August 2018

**URGENT PRODUCT CORRECTION NOTIFICATION**  
**Potential for Unsuppressed Results using VITROS® XT 7600 Integrated Systems**

Fluid on  
tip locator

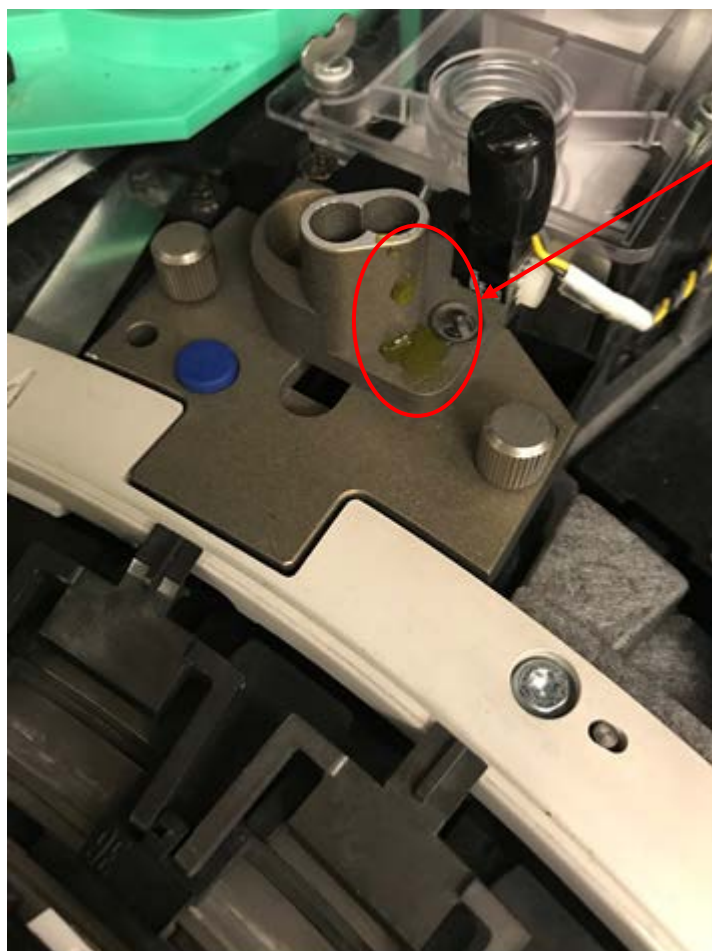
### 2. How can I determine where the Tip Locator is on my VITROS XT 7600 System?

The photograph below shows an example of fluid on the VITROS 5600 tip locator:

- If you observe unexpected MicroSlide assay results for a sample associated with TE1-504 and/or TE1-594 condition codes, please do the following:
  - Inspect the tip locator to determine if sample fluid is present. Refer to example on page three.
  - If fluid is NOT observed, repeat all MicroSlide assays for the affected sample.
  - If sample fluid is observed on the tip locator or repeated results do not agree (i.e., incorrect results), contact your local Ortho representative or our Ortho Care™ Technical Solutions Centre for further assistance.
- Complete the Confirmation of Receipt form no later than August 31, 2018.
- Post this notification by each VITROS XT 7600 System in your facility or with the user documentation.
